DART AEROSPACE LTD		Work Order:	93548
Description: Crosstube Assembly (205/212/412 High Fwd)		Part Number:	D212-664-141
Inspection Dwg: D212-664-141 Rev: D		Page 1 of 2

DRAWING NO. D212-664-141	TITLE XTUBE ASSY (205/212/412 HI FWD)	REV. D	DART AEROSPACE LTD ENGINEERING ORDER		D.E.O. NO. D212-664-141-D-1	SHEET NO. SHEET 1 OF 2	SCALE NTS
DRAWN	CHECKED	MFG. APPR.	APPROVED	DE APPR.			
DATE 11.04.07	DATE 11.04.11	DATE 11.04.12	DATE 11/04/12	DATE 11.04.12

DRAWING NO. D212-664-141	TITLE CROSSTUBE ASS'Y (205 HI FWD)	REV. D	DART AEROSPACE LTD ENGINEERING ORDER		D.E.O. NO. D212-664-141-D-2	SHEET NO. SHEET 1 OF 1	SCALE NTS
DRAWN <i>UP</i>	CHECKED <i>ASS</i>	MFG. APPR. <i>AB</i>	APPROVED <i>MD</i>		DE APPR. <i>HH</i>		
DATE 11.07.15	DATE 11.07.20	DATE 11.07.21	DATE 11/07/21		DATE 11.07.21

DRAWING NO. D212-664-141	TITLE XTUBE ASSY (205/212/412 HI FWD)	REV. D	DART AEROSPACE LTD ENGINEERING ORDER		D.E.O. NO. D212-664-141-D-3	SHEET NO. SHEET 1 OF 1	SCALE NTS
DRAWN AJS	CHECKED 92	MFG. APPR. 140	APPROVED 140	DE APPR. 140	DATE 12.06.28	DATE 12.07.05	DATE 12.07.05

**D212-664-141/-141B
ASSEMBLY DETAIL**

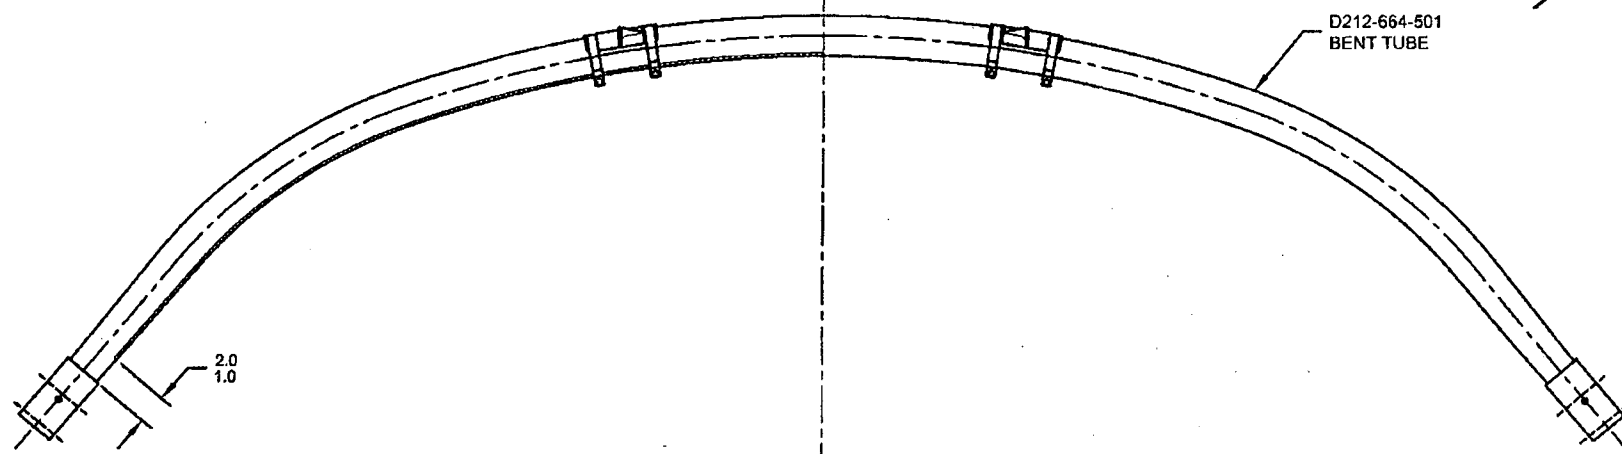
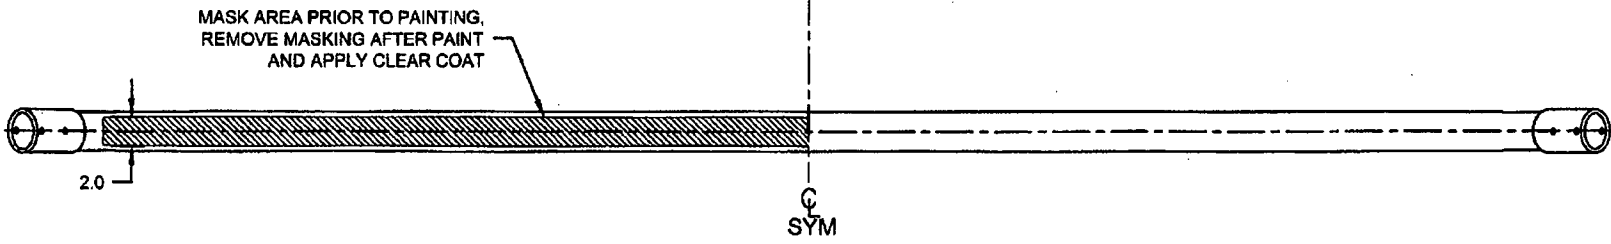
PURPOSE:

ADD AN INSPECTION WINDOW TO UNDERSIDE OF CROSSTUBE.

NOTES 2 OF SHEET 1 IS AMENDED AS FOLLOWS:

IS:

WAS:

- 2) FINISH: CHEMICAL CONVERSION COAT PER DART QSI 005 4.1
PRIME INSIDE AND OUTSIDE PER DART QSI 005 4.2
MASK UNDERSIDE OF CROSSTUBE AS SHOWN (HATCHED AREA) AND
PAINT OUTSIDE PER DART QSI 005 4.2
REMOVE MASKING AND APPLY CLEAR COAT
